SUNFISH LAKE, MINNESOTA PLANNING COMMISSION

Planning Memorandum

Re: 2 Acorn Dr. – Major Site and Building Plan Review & Variance
WSB Project No. 027923-000

Re: 2 Acorn Drive – Major Site Plan Review
City of Sunfish Lake, MN
WSB Project No. 027923-000

GRADING, DRAINAGE
AND EROSION
CONTROL PLAN

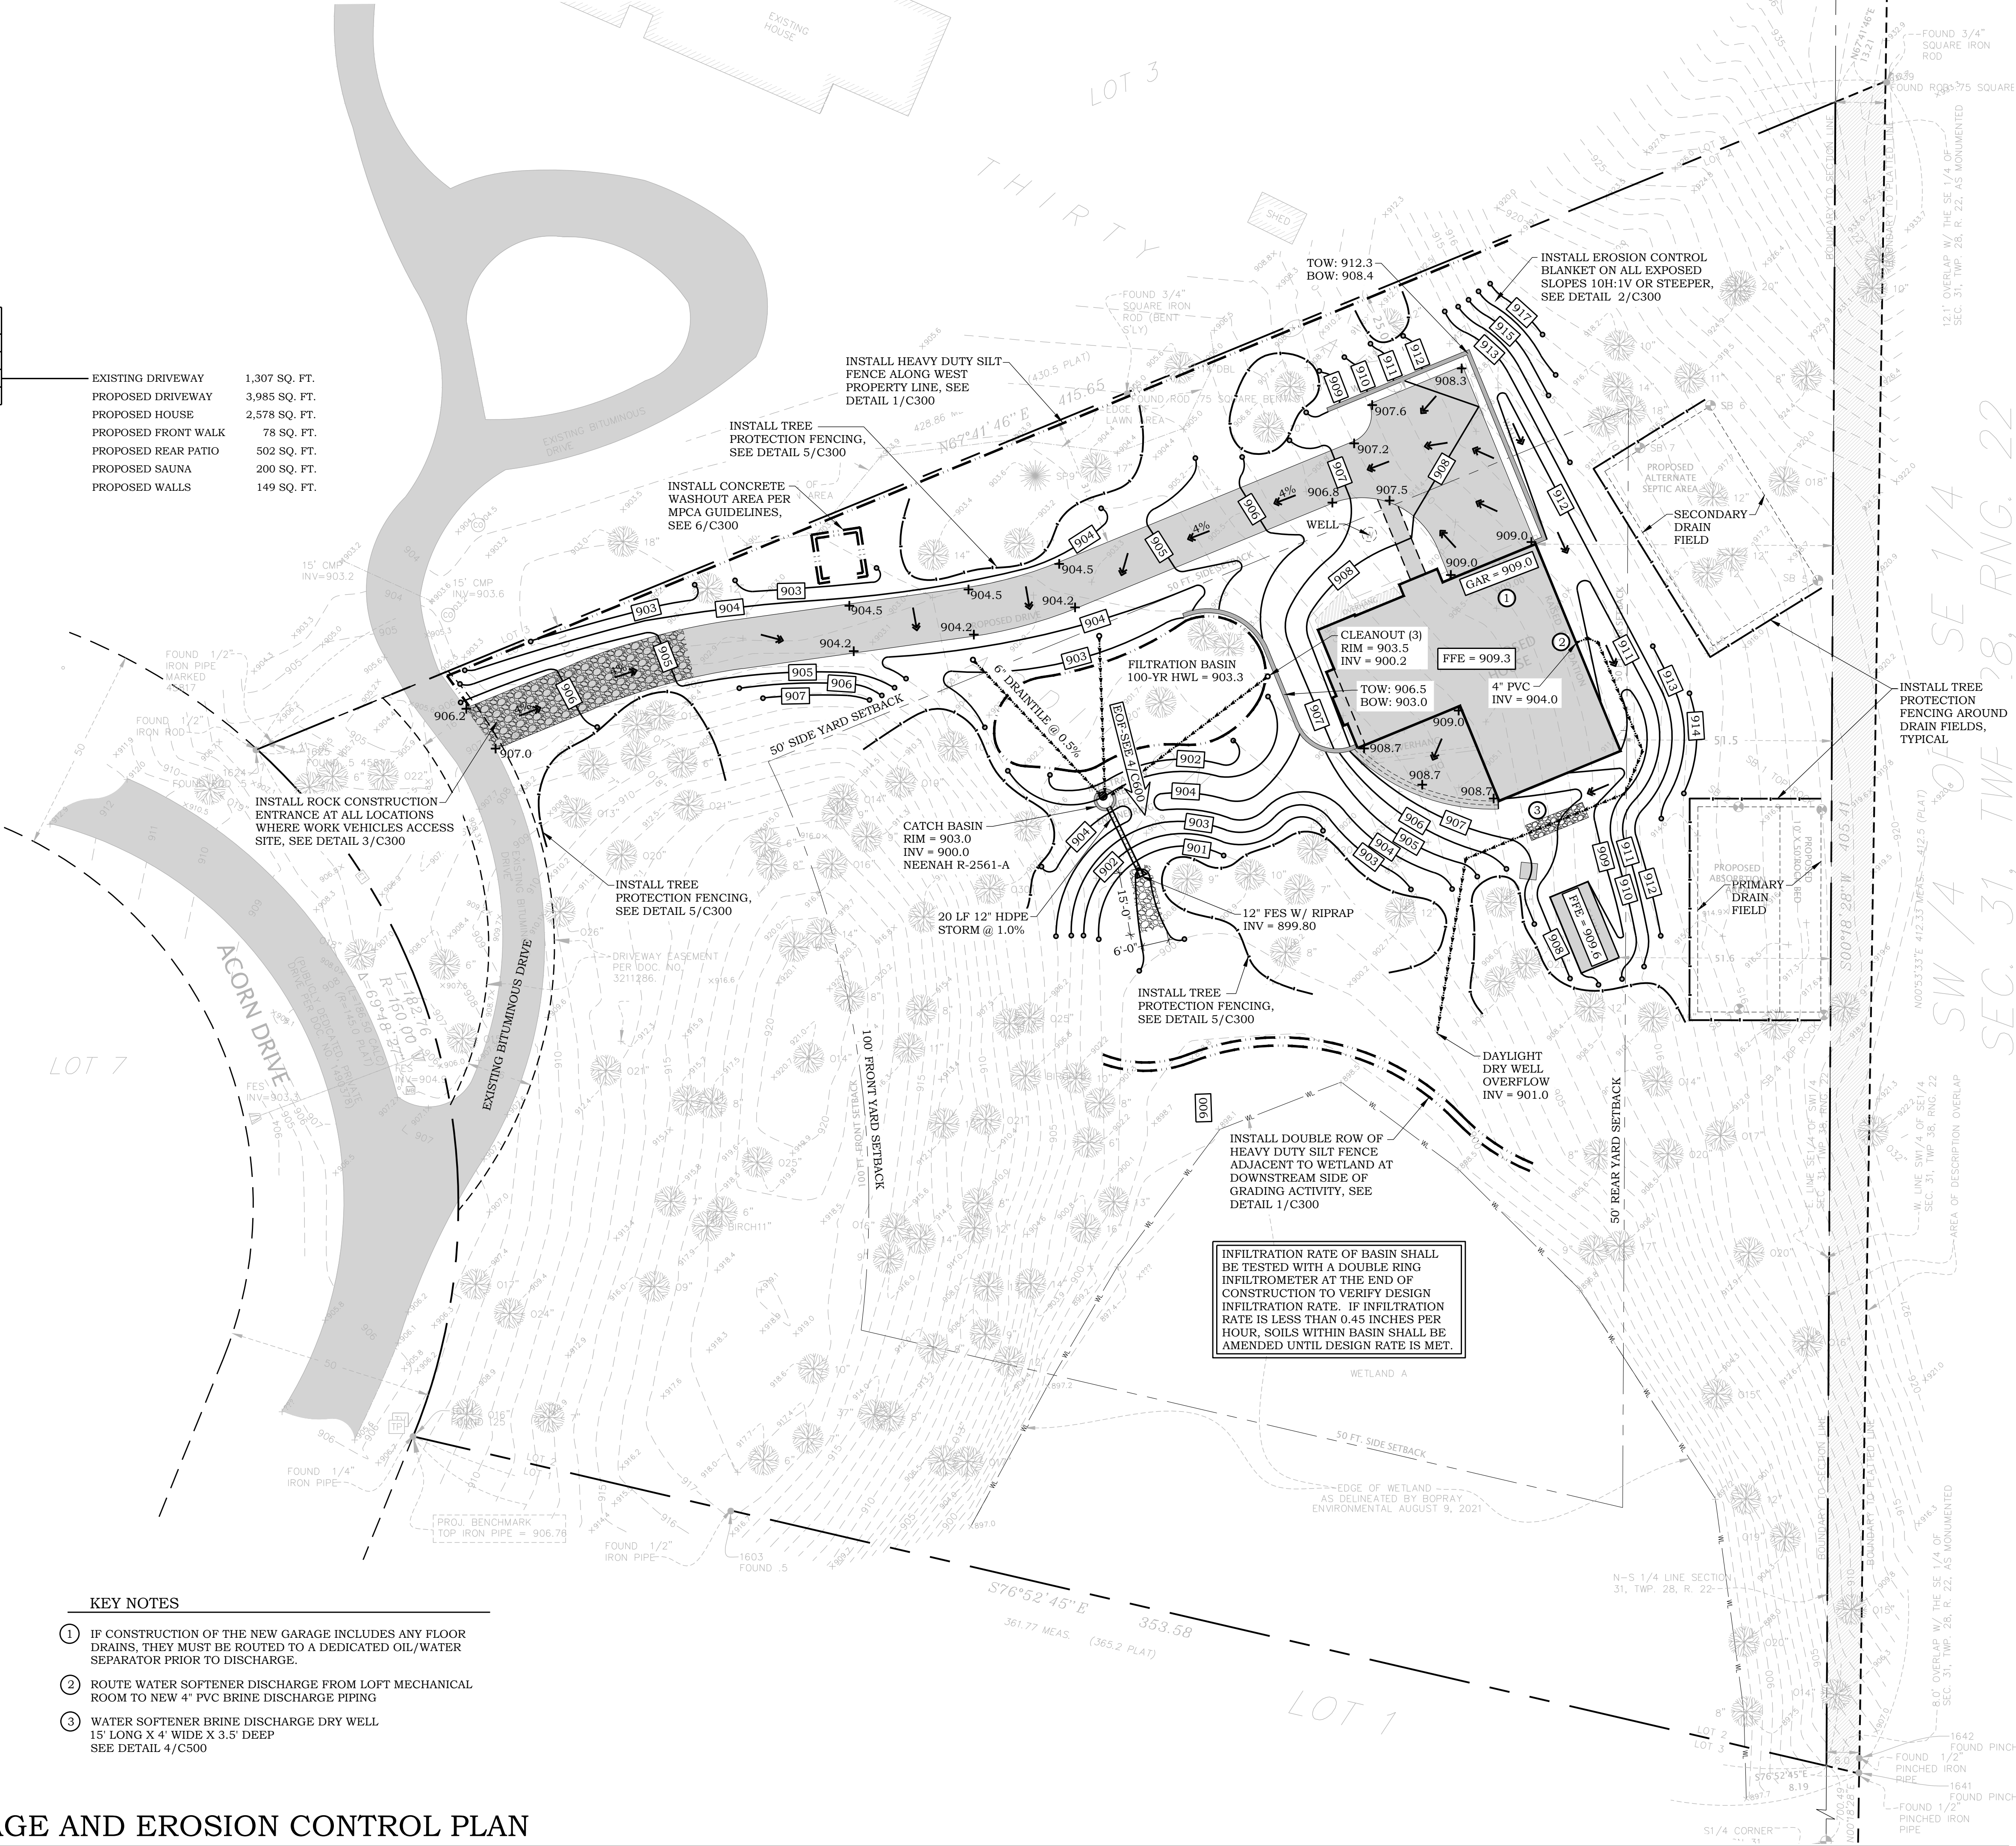
1. Please update the site construction planset accordingly:
 - a. Show/call out the utility easement
 - b. Show wetland buffer
 - c. Note the wetland HWL on the plans.

2. In the stormwater report the overflow for the wetland is noted at 904.0. Does this go over the proposed driveway? Callout the location and elevation of this overflow on the plans.

5. Confirm boundary of filtration basin, the basin footprint on the plans does not seem to match the operation and maintenance guide.
6. Minimum time of concentration to be used should be 10 minutes, update subcatchment C2.

Grading, Erosion Control and Restoration

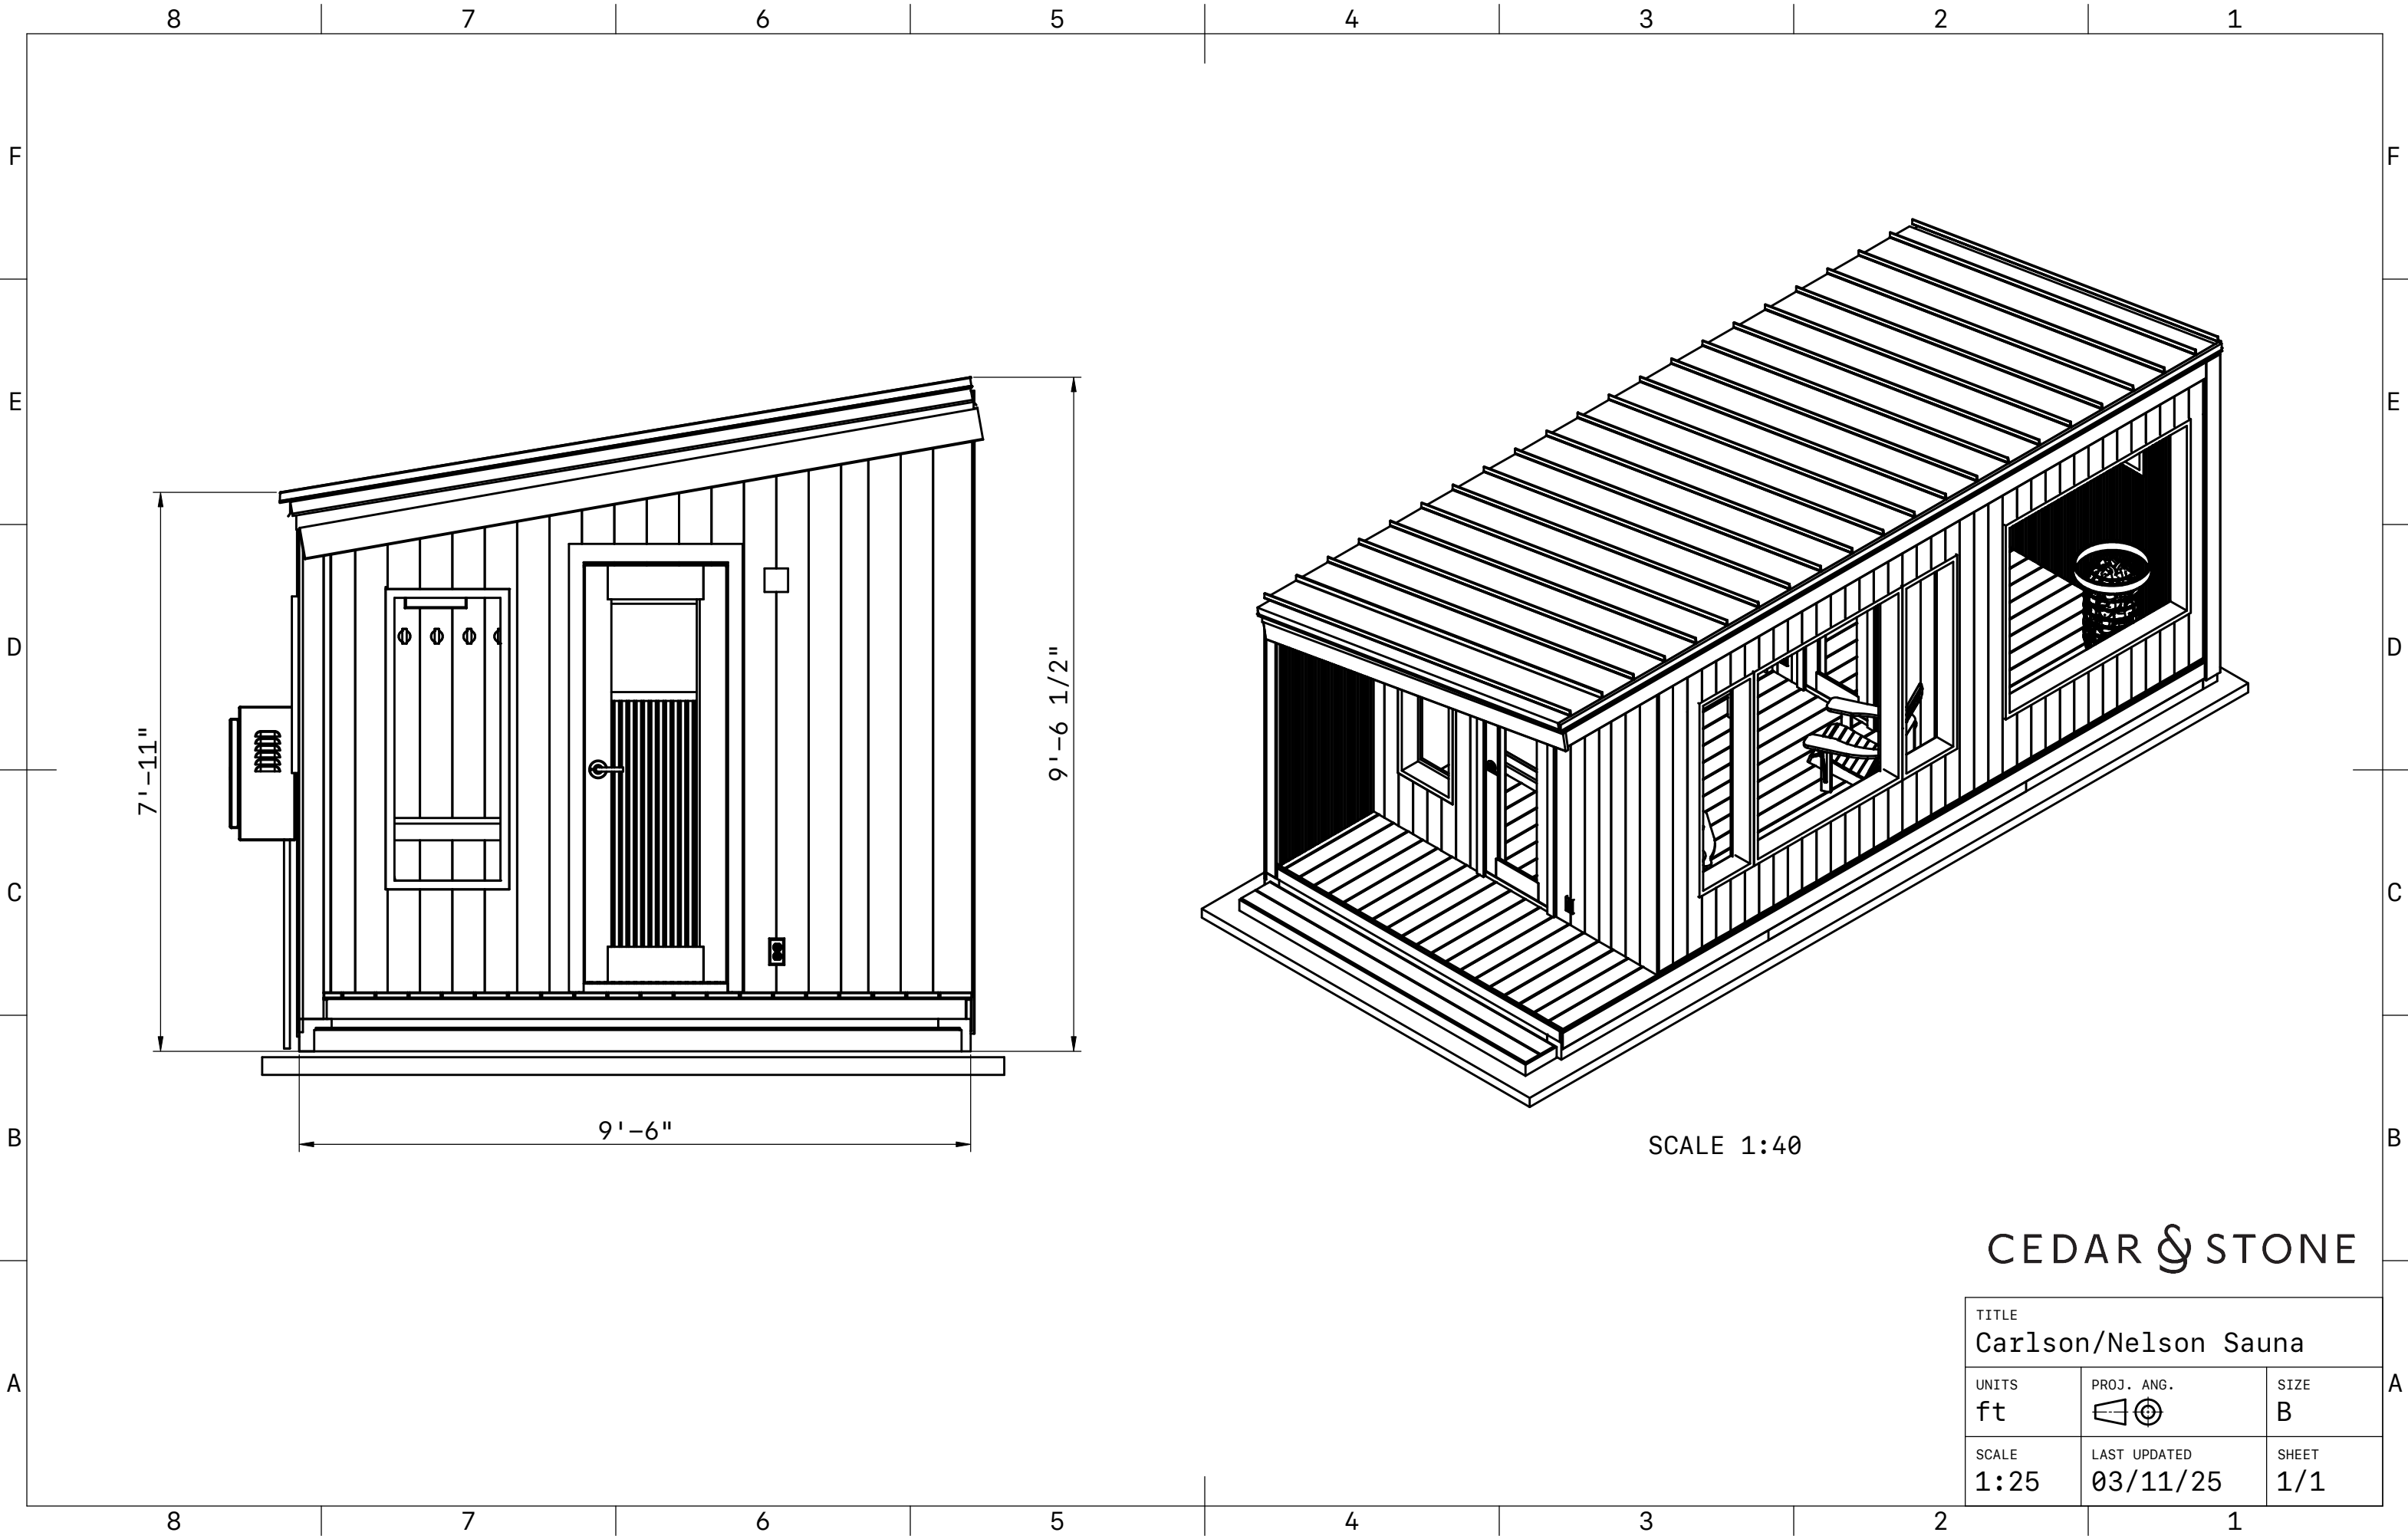
1. See the attached plan for comments related to grading throughout the site.
2. An as-built survey will be required upon project completion that demonstrates the improvements were constructed per the approved plans.
